ADDRESS: 1917 BRANDYWINE ST

Proposal: Legalize deck railings and garage door; install pergolas

Review Requested: Final Approval

Existing elevations | Wilcox Street view (looking south) : L – garage closed R – garage open

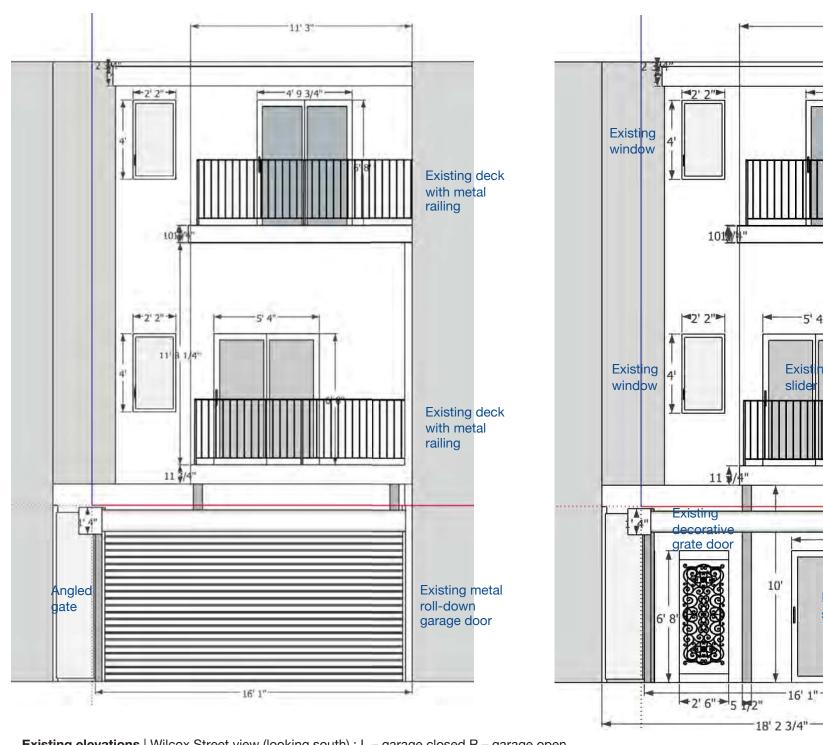
STAFF RECOMMENDATION: Approval, provided that the garage door mechanism that currently projects into Wilcox Street is relocated to the interior of the parking area and is not visible from the right of way, and a sample of the polycarbonate panels is reviewed prior to final approval, pursuant to Standard 2.

Proposed elevations | Wilcox Street view (looking south) : L - garage closed R - garage open, also see dimensioned drawings

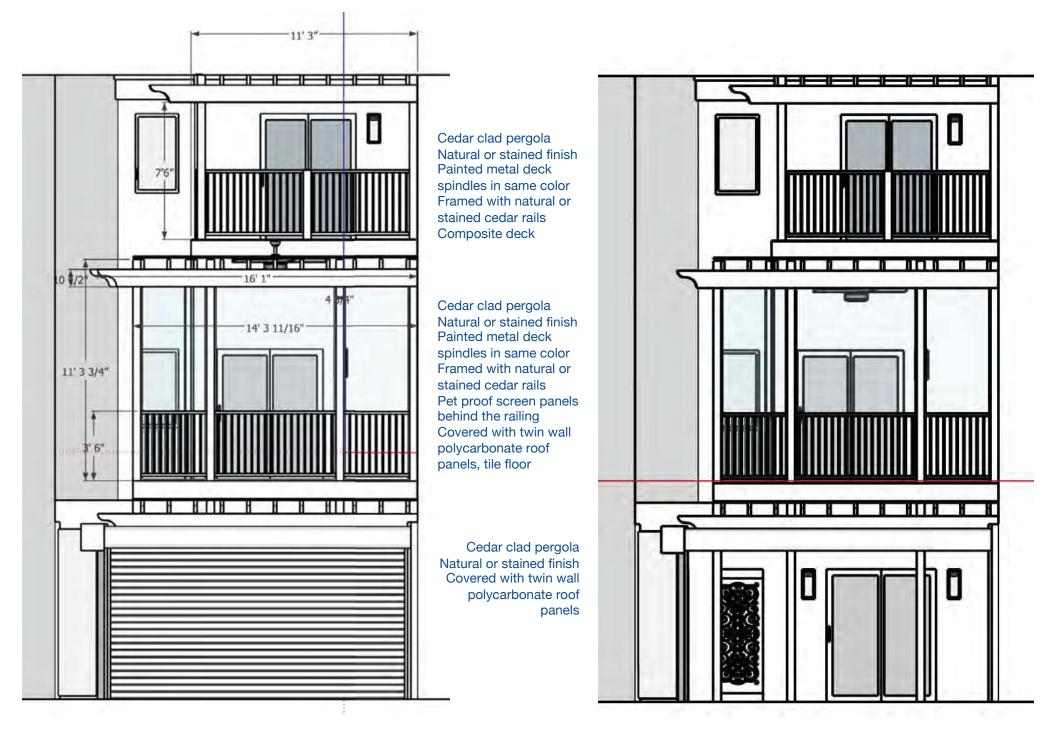
- The staff requests that a sample of the polycarbonate panels is provided for review.
